STATE OF NORTH CAROLINA
DEPARTMENT OF TRANSPORTATION

June 12, 2008

Subject: **Notification of Construction Revisions** for the construction of the High Point East Beltway, US 311 from south of US 29/70 to US 220, in Guilford and Randolph Counties, TIP R-609IA.

PROJECT REFERENCE NO. **R-06091A** SHEET NO. **11**

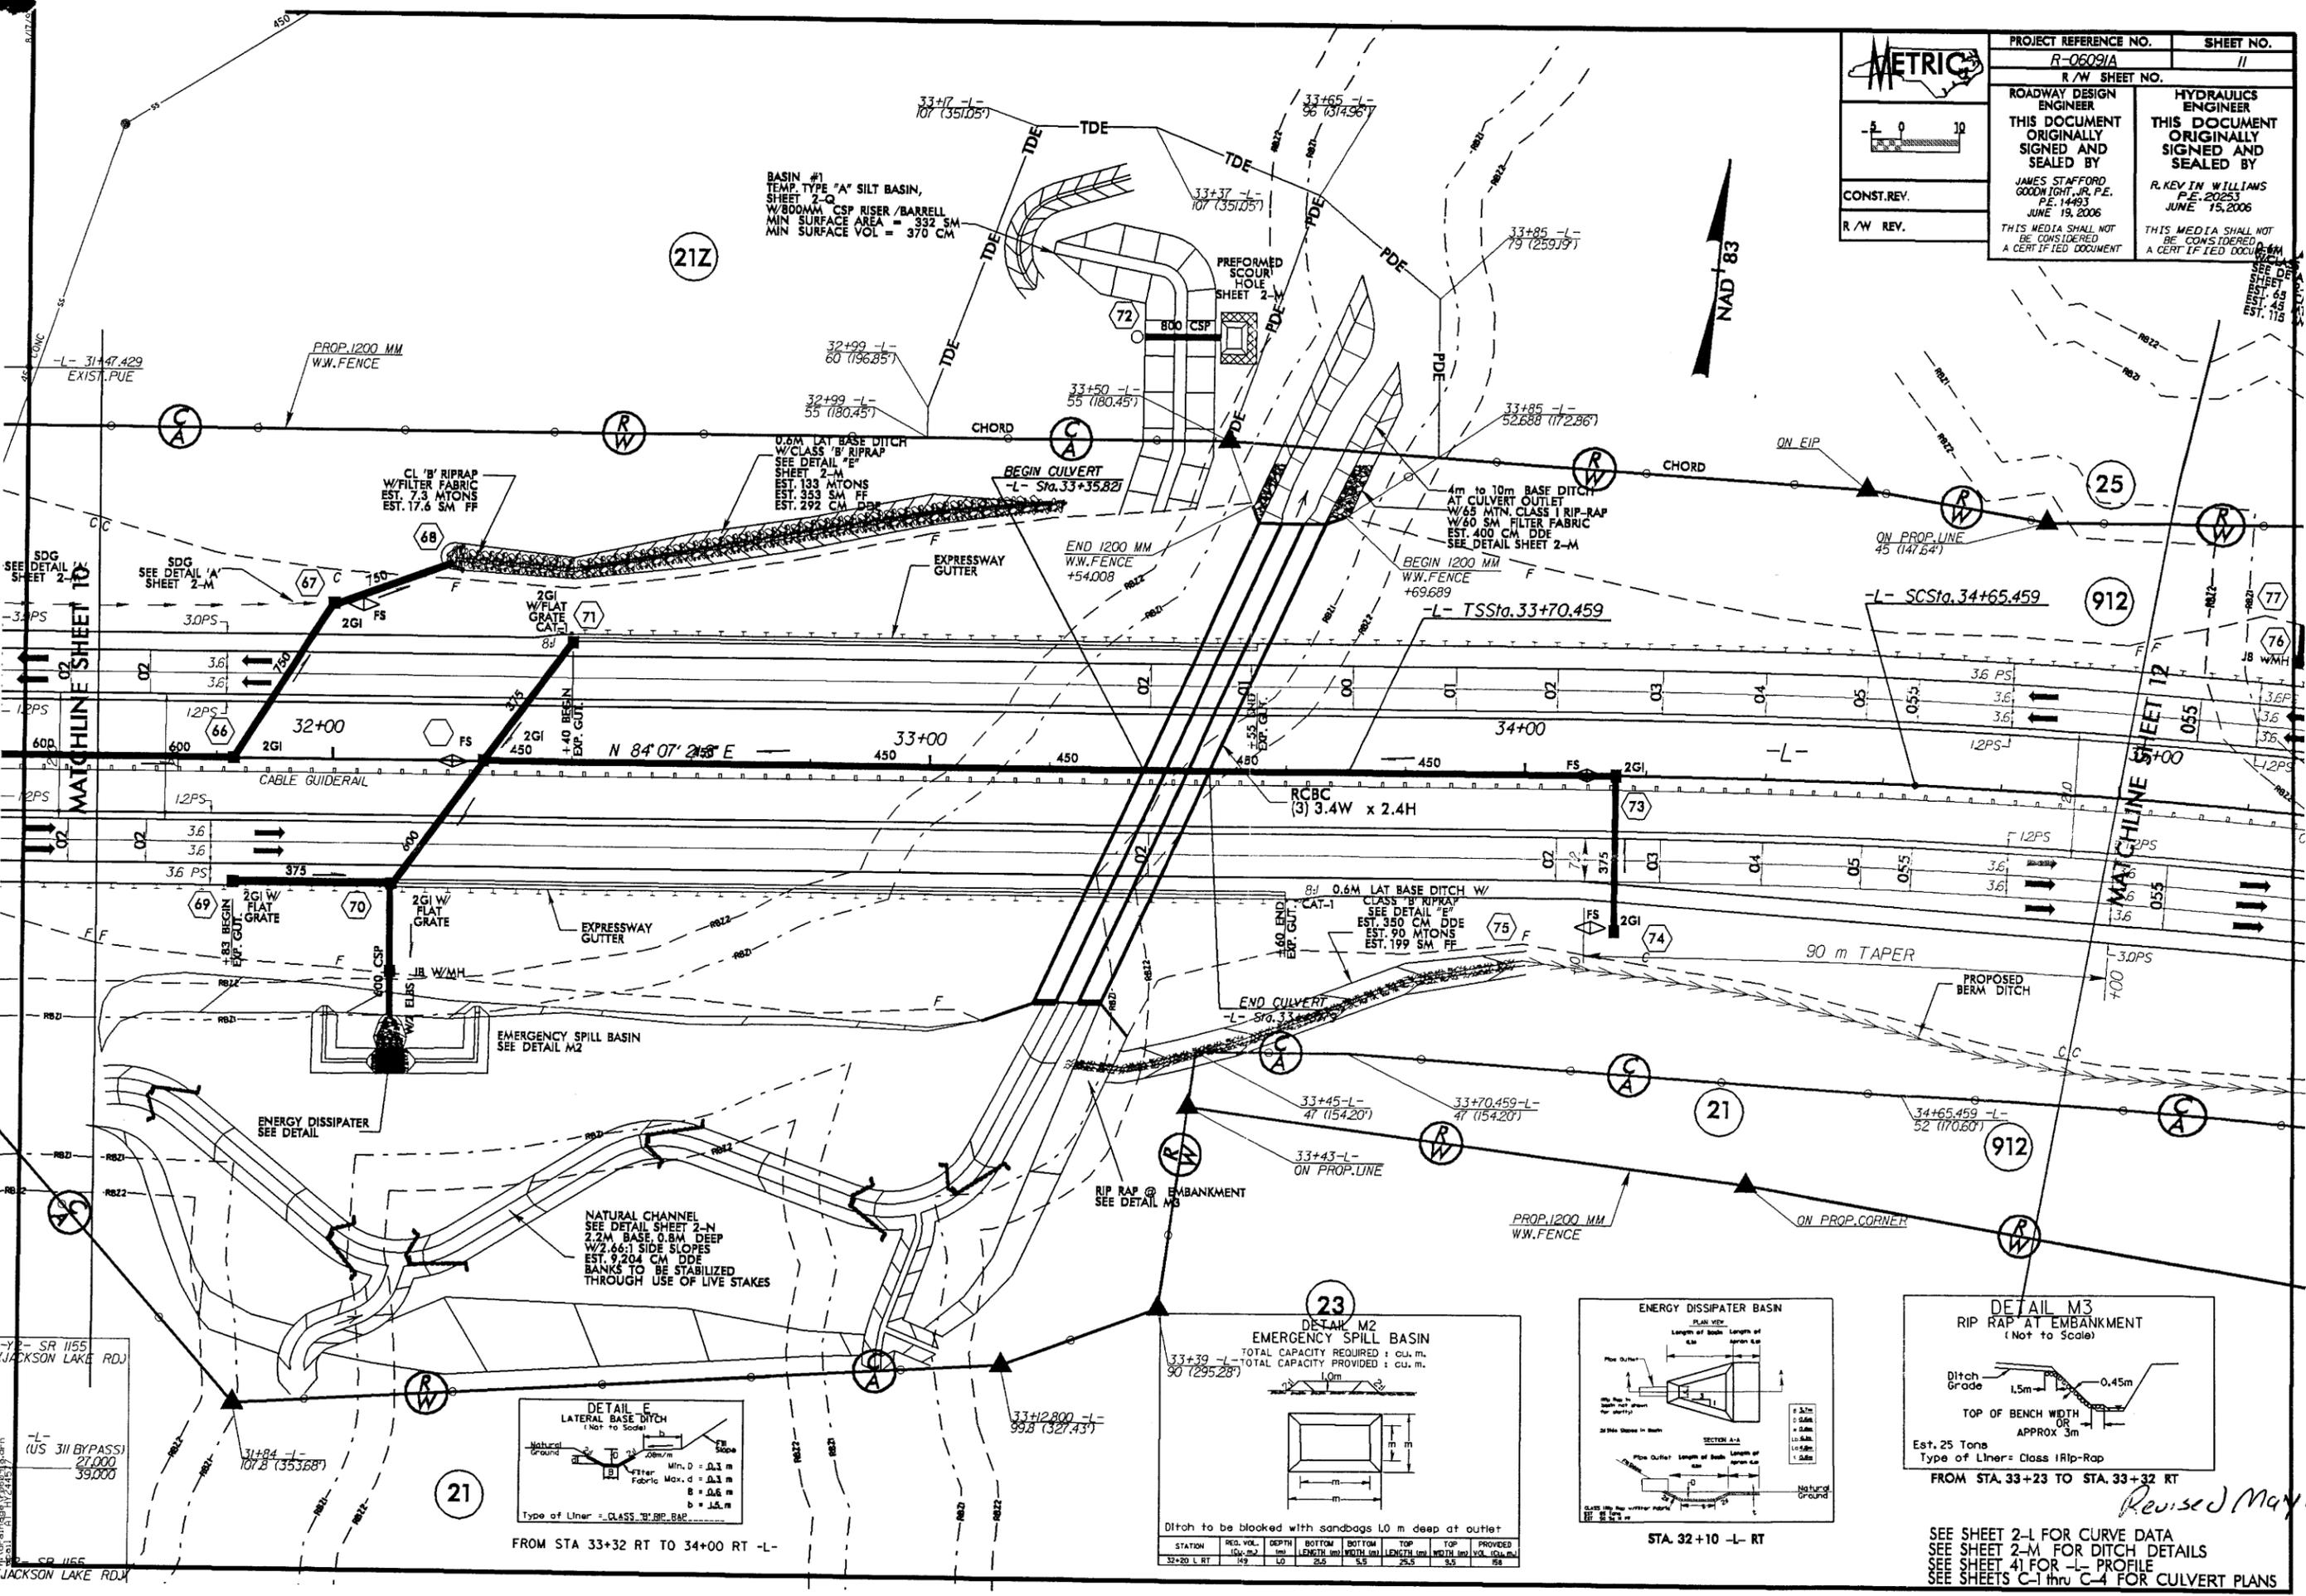
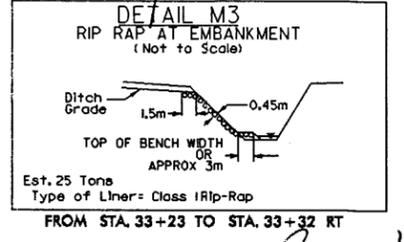
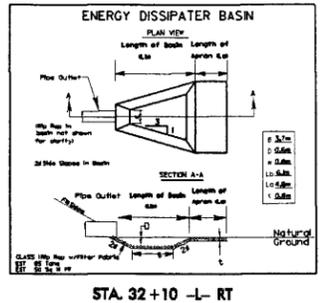
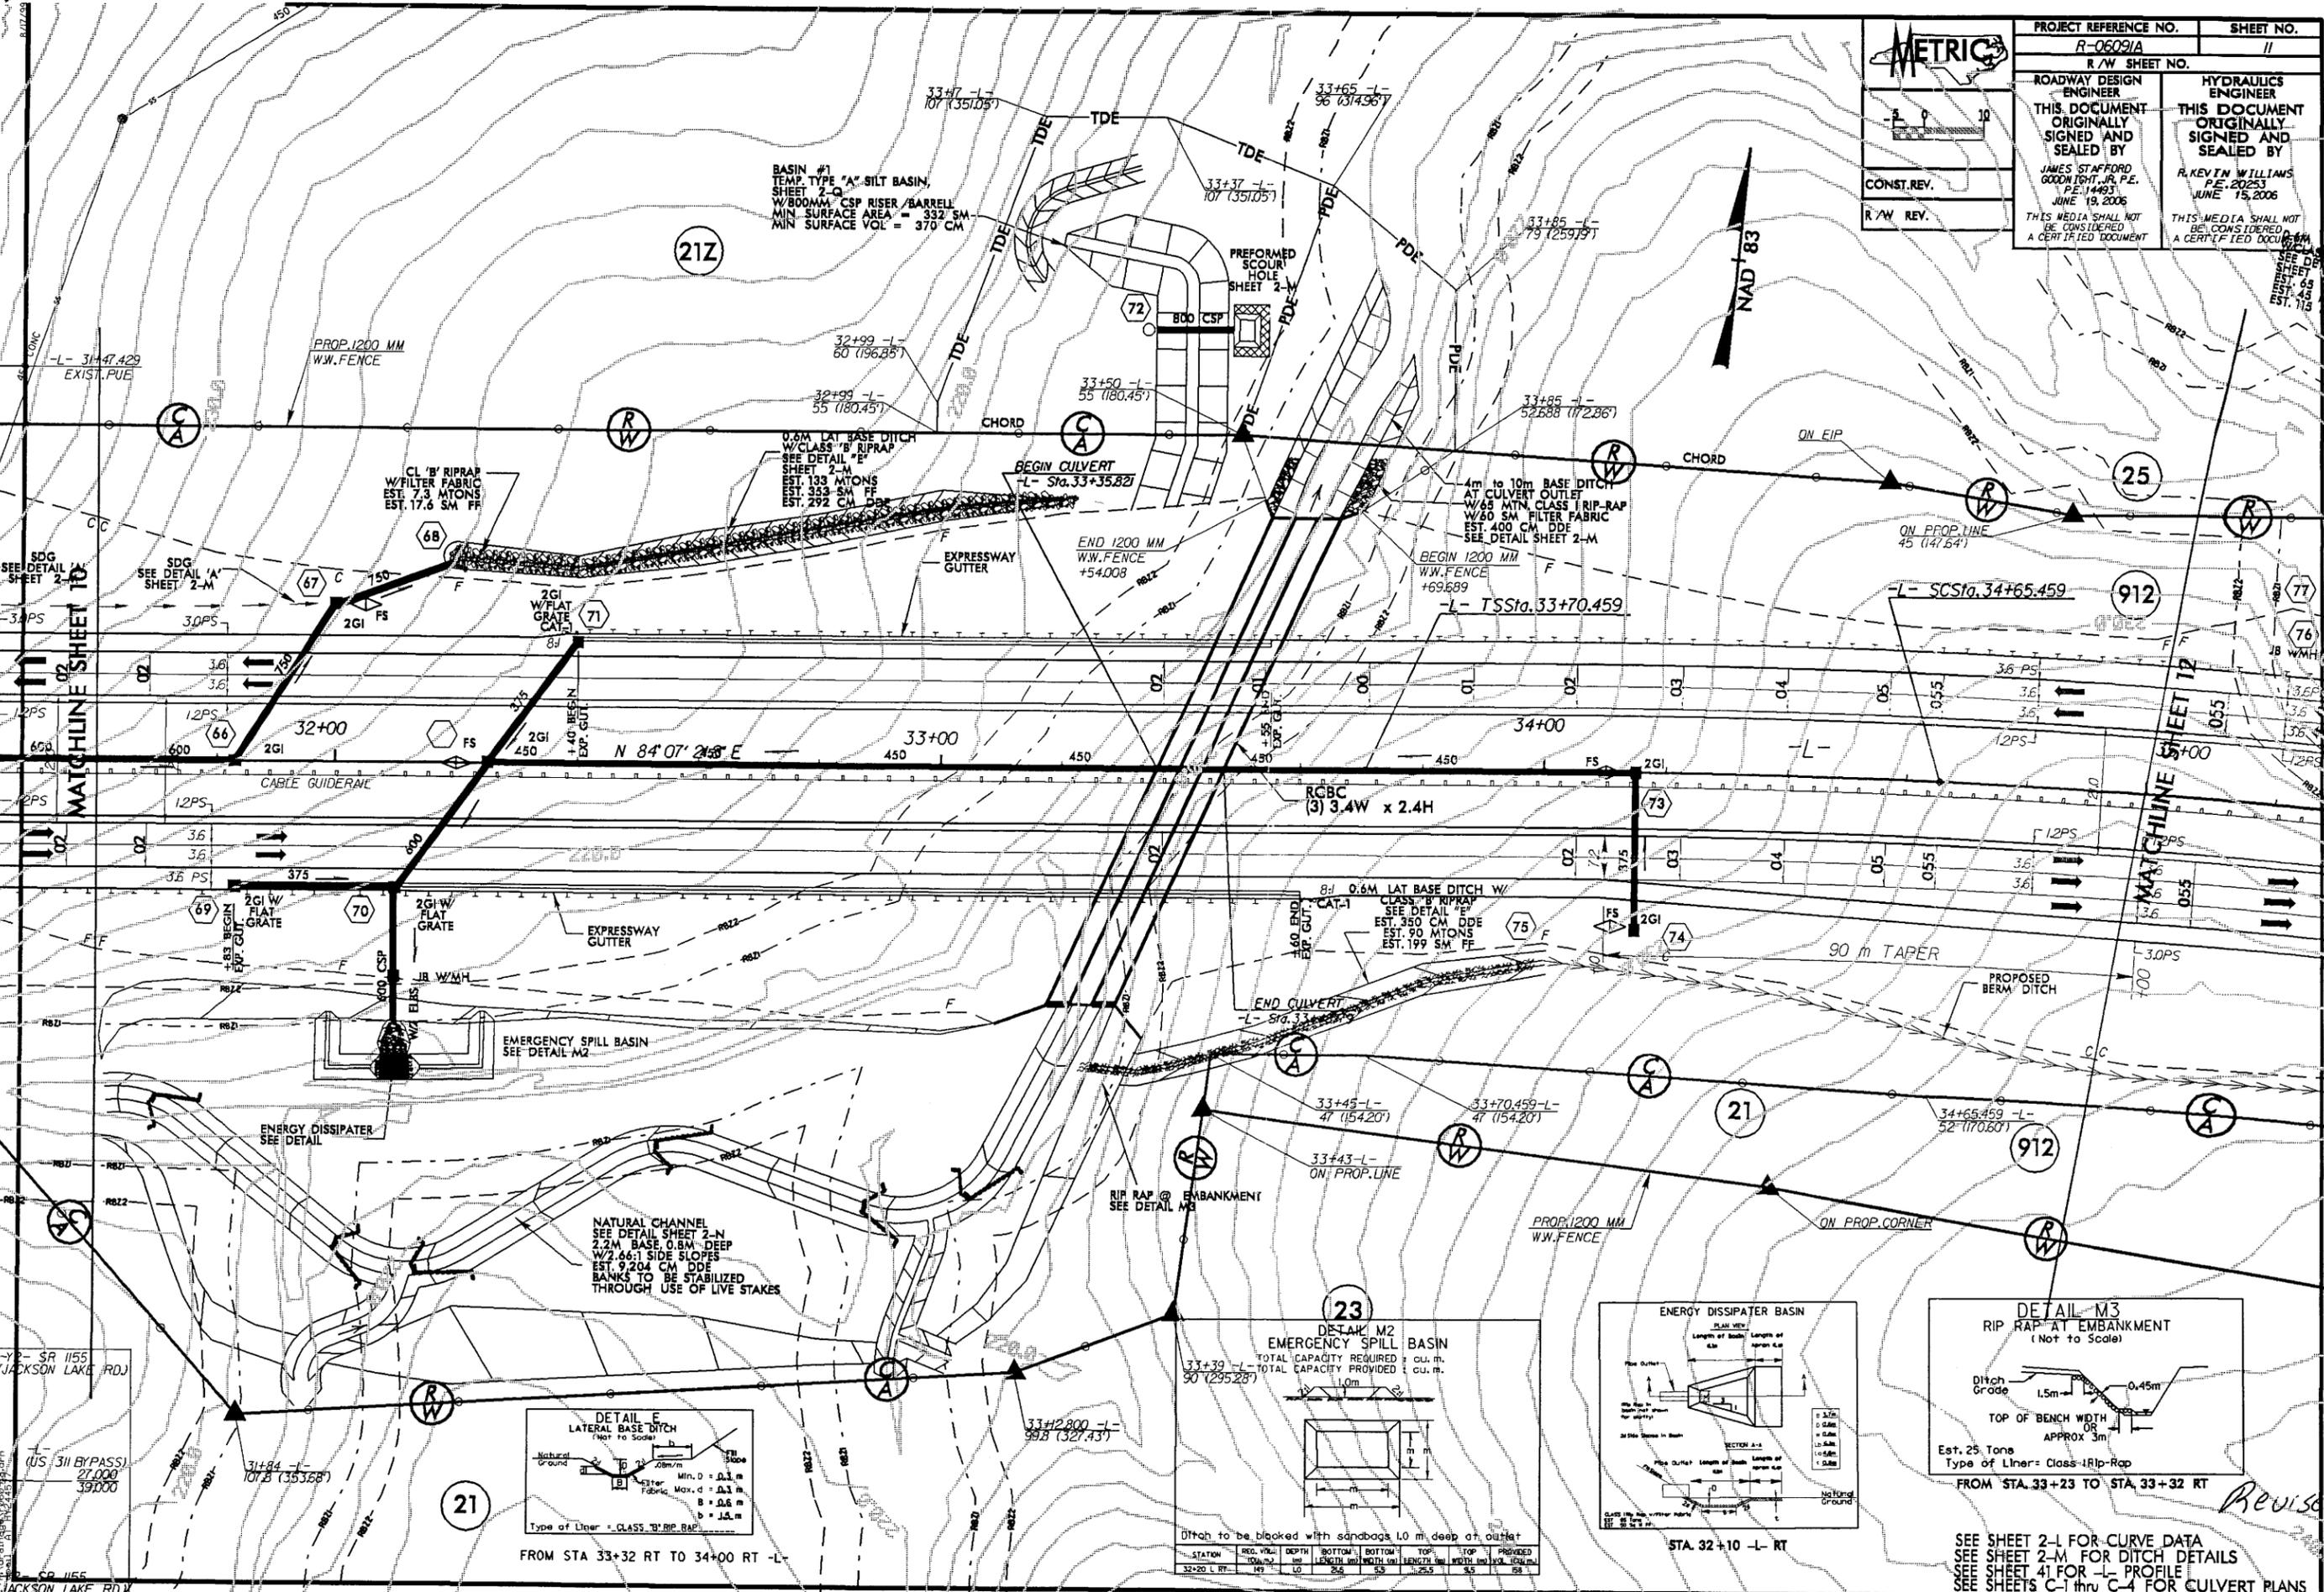
Please find enclosed a copy of revised plan sheet 11 for TIP project R-609IA. Revisions to the plan sheet include the relocation of the outfall for a grated inlet, relocation of the Hazardous (Emergency) Spill Basin and the removal of a level spreader. The proposed changes to the project design will not change the amount of impacts to regulated Waters of the U.S. or stream buffers.

The grated inlet located at Station -L- 34+15 will now discharge into the 600mm pipe located at Station -L-32+25. The 600mm pipe will then discharge into the Hazardous Spill Basin and energy dissipater that is located at Station 32+20. Under the previous design the Hazardous Spill Basin was located at Station -L- 34+00. The discharge of the grated inlet and the Hazardous Spill Basin have been relocated in order to provide treatment for all storm water discharged on the south side of the proposed roadway. Under the previous design only water that was discharged to the west of the UT to Richland Creek would receive the protection from the Hazardous Spill Basin.

After field discussions between Sue Homewood of NCDWQ and Jamie Lancaster of NCDOT on March 25, 2008, the level spreader located at Station -L- 33+40 will not be constructed. The steep topography in the vicinity of the level spreader could result in erosion down slope;

therefore the level spreader will not be constructed. The ditch will remain in the same location as the original project design, however due to the revisions mentioned in the above paragraph, the ditch will only convey drainage from offsite the proposed project.

NCDOT requests that the above mentioned construction revision be handled without requiring a permit modification. Enclosed are 2 copies of revised plan sheet no 11 of 37 for your records. If you have any questions or need additional information, please contact Brett Feulner at (919) 715-1488.
